**UNITED STATES ENVIRONMENTAL PROTECTION AGENCY**

Re: BP America Production Company  
Florida River Compression Facility  
Title V Permit – Renewal #1  
# V-SU-0022-05.00

**Enclosure - Response to Comments on the Florida River Compression Facility's  
March 28, 2008 Draft Title V Permit to Operate**

BP America Production Company  
Florida River Compression Facility  
Basic System Flow Diagram

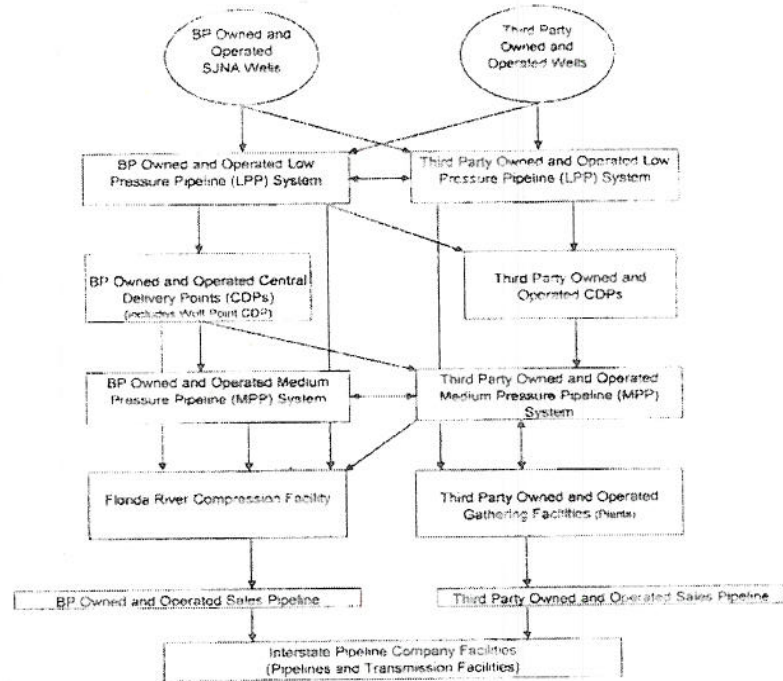
WEG suggested in their comments to EPA Region 8 that EPA should aggregate Florida River with Wolf Point and numerous BP-operated wells across the NSJB as support facilities to Florida River since they are interrelated. According to WEG, "Some or all of BP's coalbed methane wells clearly provide coalbed methane gas to the Florida Compression Facility. Thus the facility depends upon the operations of these wells for its function. Similarly, all or some the coalbed methane wells owned and operated by BP depend upon the Florida River Compression Facility for their operations. Without the existence of the Florida River Compression Facility, all or some of BP's coalbed methane wells would cease to operate as there would be no means of compressing, processing, and transporting natural gas to market pipelines."<sup>13</sup> While WEG makes these allegations, they provide no support for them.

**3. The activities are not contiguous and adjacent.** While Florida River Compression Facility, Wolf Point Compressor Station, and NSJB wells are not contiguous, WEG asserts that Florida River Compression Facility, Wolf Point Compressor Station, and all the wells in the NSJB field are "adjacent" and "interrelated" to one another, and thus must be considered a single source under both PSD and title V.<sup>14</sup> In so doing, WEG argues that two facts alone – the co-location of the various emission points within the NSJB field and the ability of those points to supply gas to the Florida River facility – are enough to make all of these various emission points a single source.<sup>15</sup> However, WEG's argument is inconsistent with EPA's past statements interpreting the "contiguous and adjacent" part of the source definition. While it is true that EPA found that non-contiguous emissions points separated by significant distances can be "adjacent" (and thus a single source) based on their interrelatedness, such determinations were only made in circumstances in which those emission points had a unique or dedicated interdependent relationship with one another.<sup>16</sup> That is not the case here. As explained below, while gas from Wolf Point and the various wells *can* supply gas to Florida River, they can also supply gas to other non-BP facilities in the field and thus do not have the type of dedicated interrelatedness that was determinative in other EPA statements on this issue.

“BP gas” is transferred to third parties or vice versa, the gatherer takes custody of and assumes liability for the gas while in the gatherer’s possession, the gas is measured by the gatherer, and the shipper verifies those volumes with its own check meter.<sup>28</sup> The following process flow diagram illustrating the flow of gas in the field demonstrates the lack of a unique connection between BP facilities.<sup>29</sup>

While the entire NSJB gas field is highly integrated, the record shows that the individual well site operations, compression, and gas processing are conducted by completely separate and distinct equipment, such that gas metered at one well head can flow to several low-pressure gathering lines which may be owned or operated by BP or by other companies. Therefore, regardless of where the well site is located in relation to other emission points and regardless of who owns or operates those emission points, once the gas is pumped, it enters these intermediate pipelines, mixes with gas from several other companies, and is sent to various compressor stations and gas plants. Gas handled by Wolf Point is compressed and dehydrated, and then flows – via medium-pressure pipelines operated by BP or third parties – to Florida River or to other third-party-operated CDPs. Thus, Florida River can continue to operate regardless of whether Wolf Point or one, two, three, four, or all of the BP operated well sites were to shut down – and vice-versa.<sup>32</sup> The nature of movement and mixture of the gas product pumped from the wells in this field means that no one well site (or compressor station) is more interrelated to or dependent on Florida River than any other well site, such that operations at Florida River do not have an exclusive or dedicated interrelatedness with Wolf Point or the BP operated well sites.

Taking into consideration the complex and diverse gas movement among the facilities, as well as the lack of unique interdependence among the facilities, EPA has determined that the Florida River Compression Facility, Wolf Point Compressor Station, and BP's numerous well sites within the NSJB are not adjacent.
